VIRTUAL ONLY
PLAN COMMISSION
MEETING NOTICE AND AGENDA
Thursday, November 19, 2020
7:00 PM

REPORT TO THE PLAN COMMISSION

Project Name: Waukesha Gun Club Site & Building Plans

REV.	07/08/2020	ADD PROP. BLD.
REV.		
REV.		
REV.		
REV.		
LOCATION	N22W23170 WATERTOWN RD. WAUKESHA, WI.	
CLIENT	ASCENT	
PROJECT	WAUKESHA GUN CLUB	
LAYOUT	PLAT OF SURVEY	
DRAWING	20140_SURVEY.DWG	
DRAWN BY	LJS	CHECKED BY MTO
SCALE	1:30	
DATE	07/01/2020	
JOB NO.	20140	
SHEET	1 OF 1

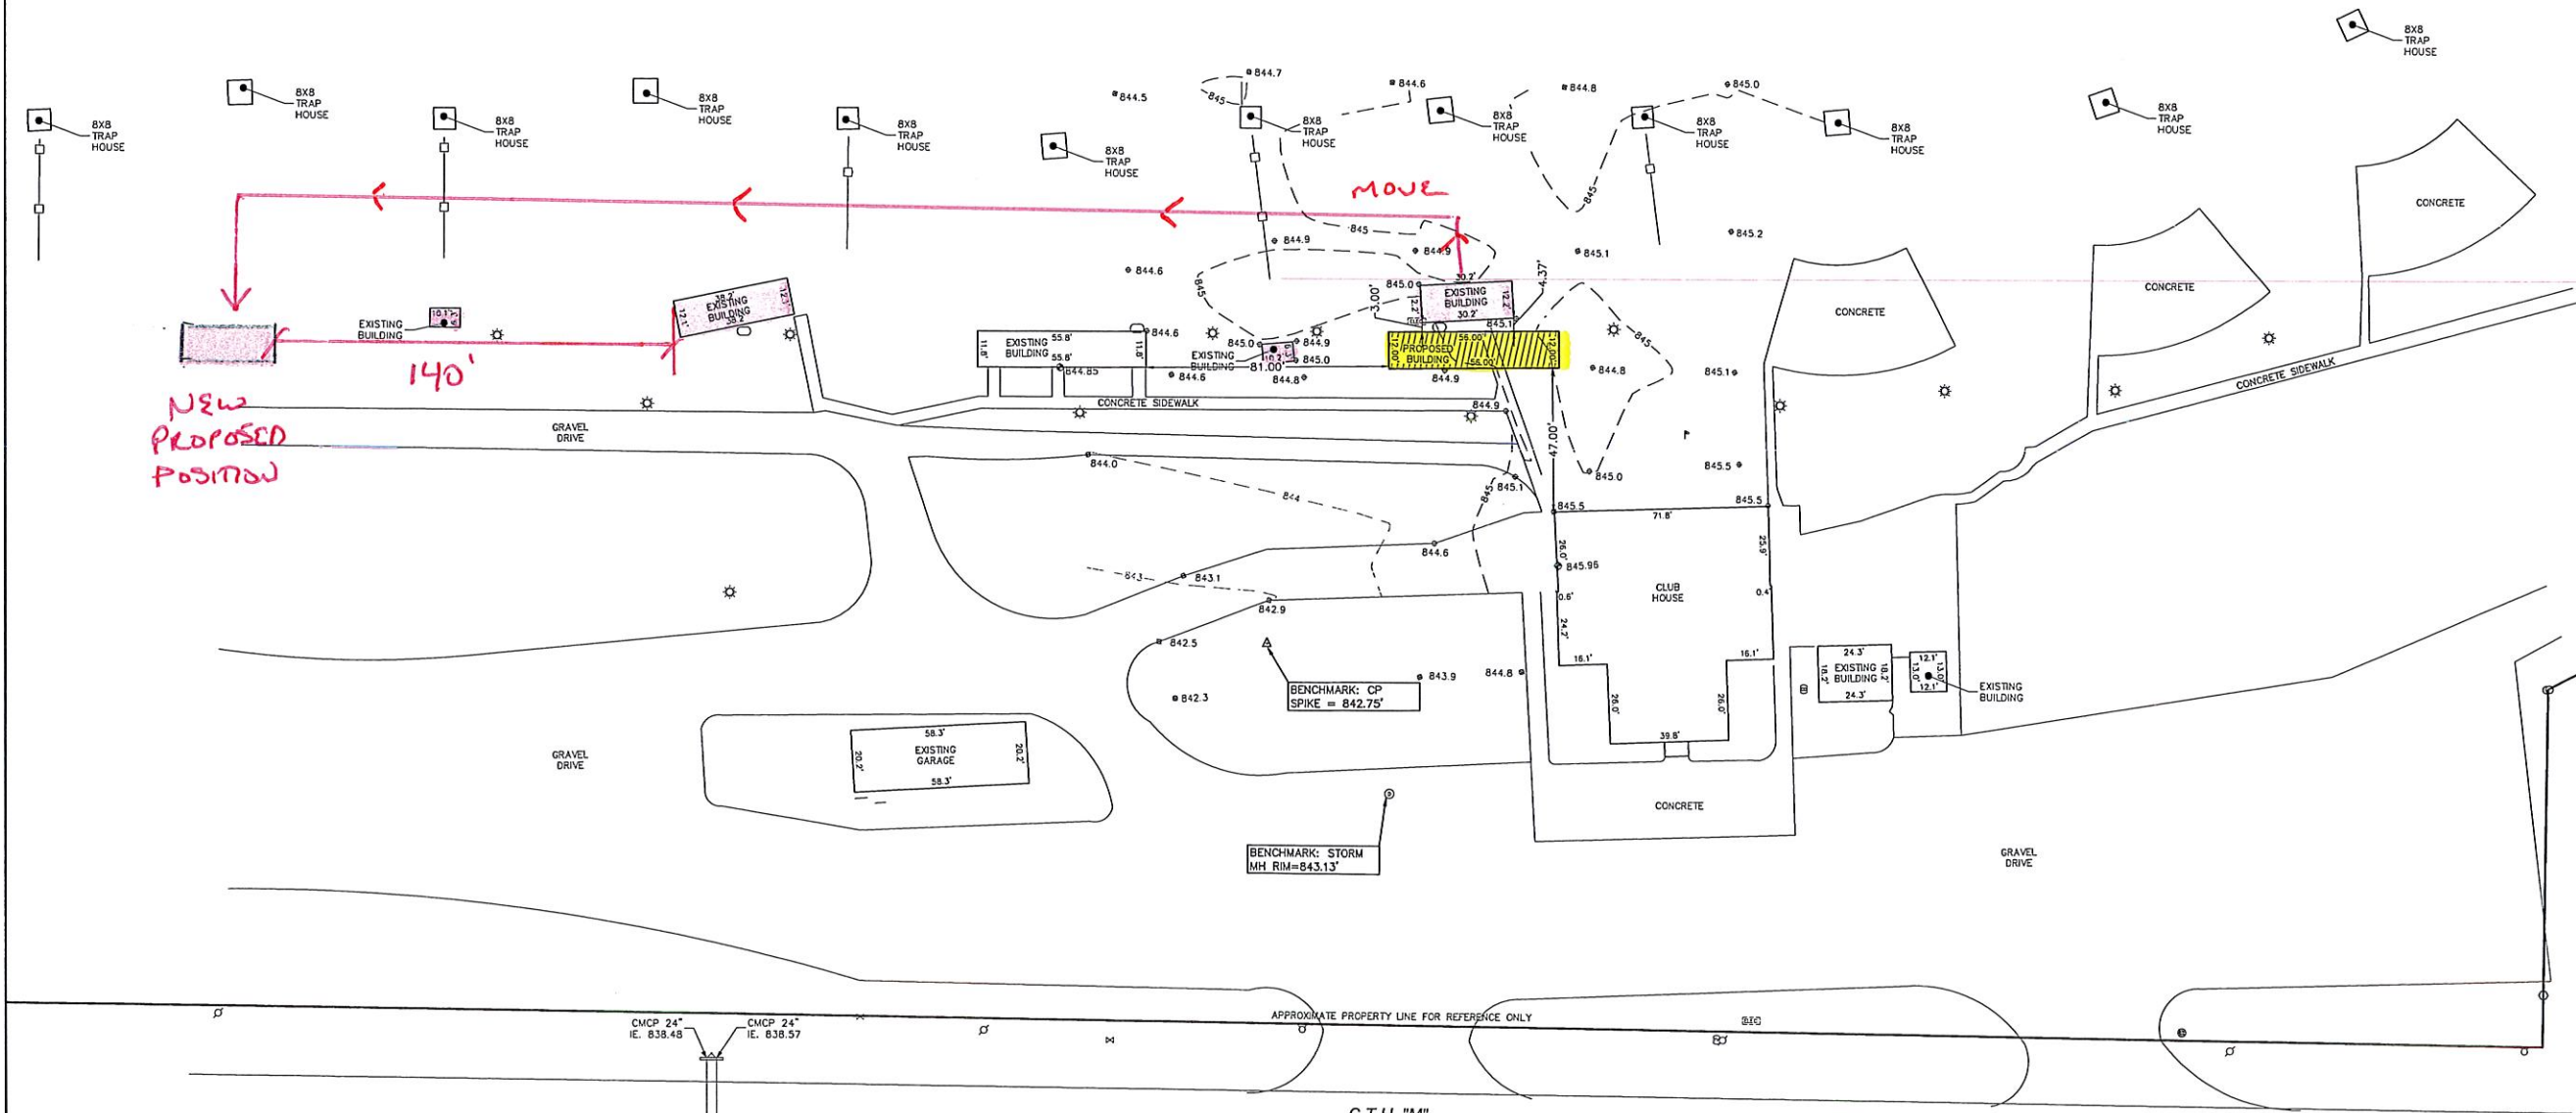
- Has a wetland delineation ever been conducted onsite?
- Please provide an additional site plan that illustrates property lines. A scaled site plan with setbacks dimensioned is preferred, including setbacks for WDNR mapped wetlands.

- The site plan shows existing lighting to remain. Please confirm that no new lighting is proposed as part of this project.
- It is also recommended that a Certified Survey Map be submitted to combine the 4 separate parcels owned by the Waukesha Gun Club. These properties function as a single development, so it recommended they be combined, which would eliminate any potential zoning setback issues. I believe the City would be open to a time frame that would allow the shooting stand to proceed while the CSM moves forward separately at a later date.
